ITEM FOR ENVIRONMENTAL BOARD AGENDA

NAME & NUMBER OF PROJECT: 3213 Smoky Ridge
SP-2013-0398DS (Withdrawal and Resubmittal of SP-2012-0366DS)

**Planning and Development Review Department
Staff Recommendations Concerning Required Findings
Water Quality Variances**

MEMORANDUM

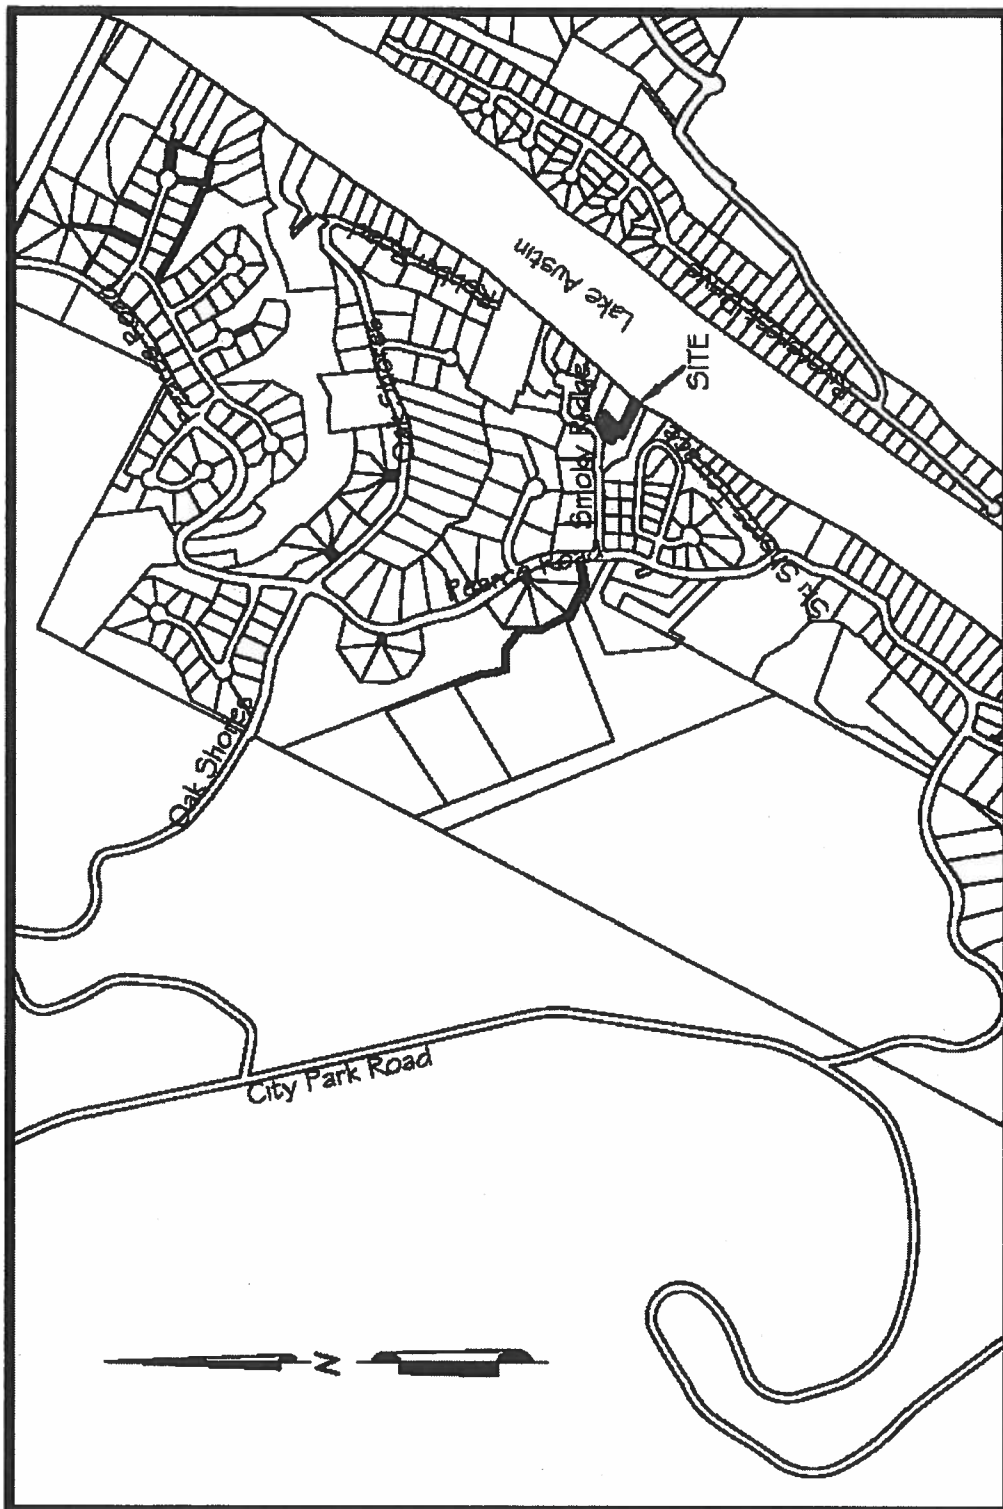
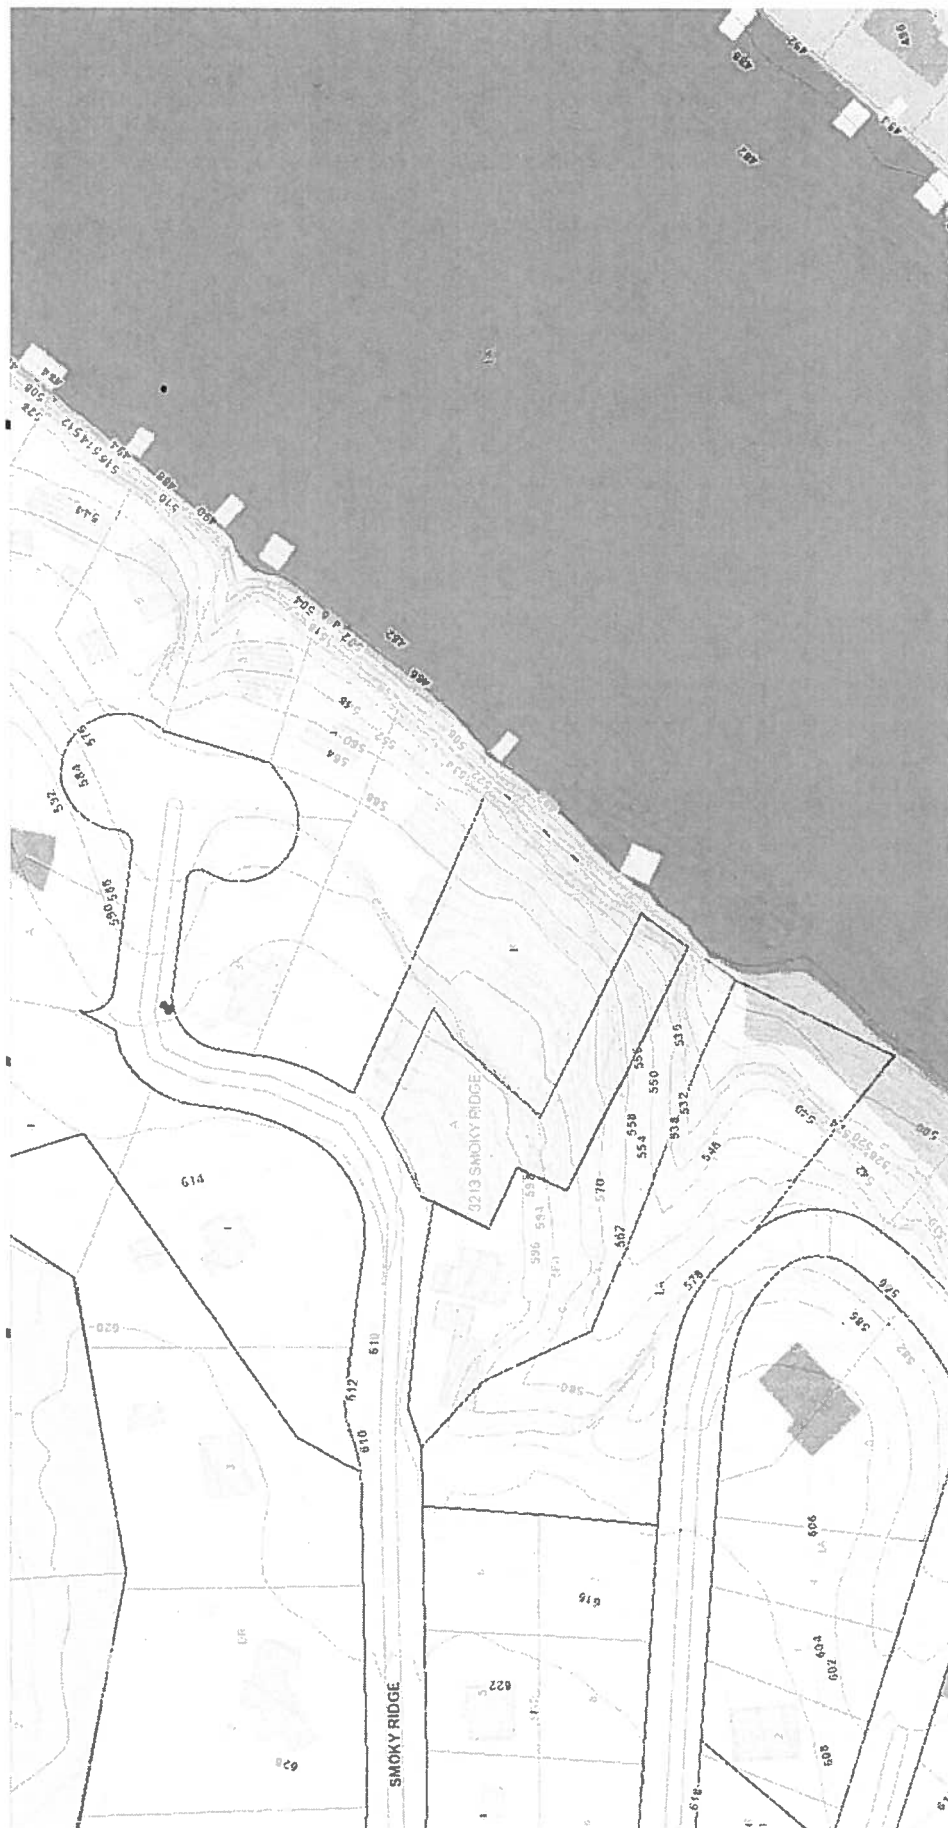
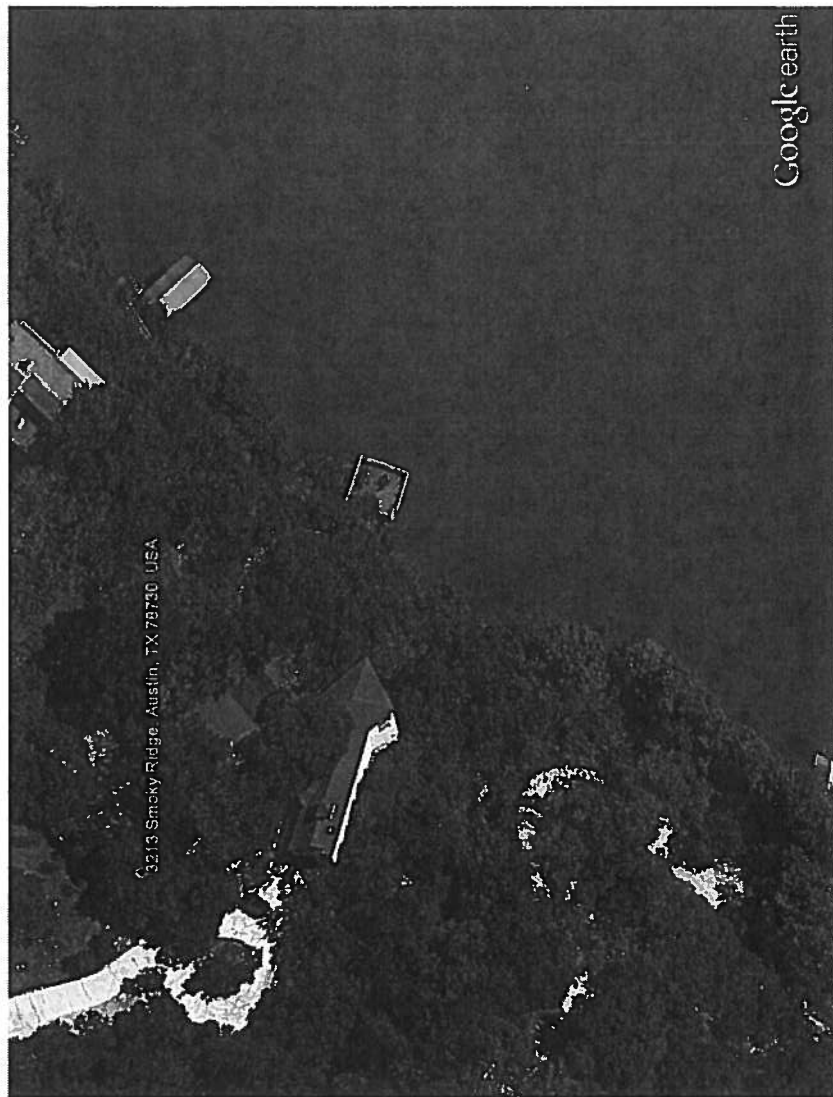
Per the request of Sylvia Pope with the City of Austin I am presenting this explanation of the proposed framing system considering the protection of the existing Rim Rock.

The system shown on our drawing **SK1**, dated October 10, 2013, shows that the stair framing extending from the top of the Rim Rock to the water level is supported at the top of the Rim Rock at the high side and with driven steel piles into the lake bed at the low side.

By framing in this manner, there is no distress or contact with the grade below the Rim Rock as the stair framing is suspended from the beam which extends from the footing over the Rim Rock to the extended column supported by the pile within the lake bed.

The footing over the Rim Rock shall be cast 3'-0" back from the edge so that the load is not at the outside edge of the rock. This footing can be cast directly onto the rock after any loose soil material over the rock is removed.
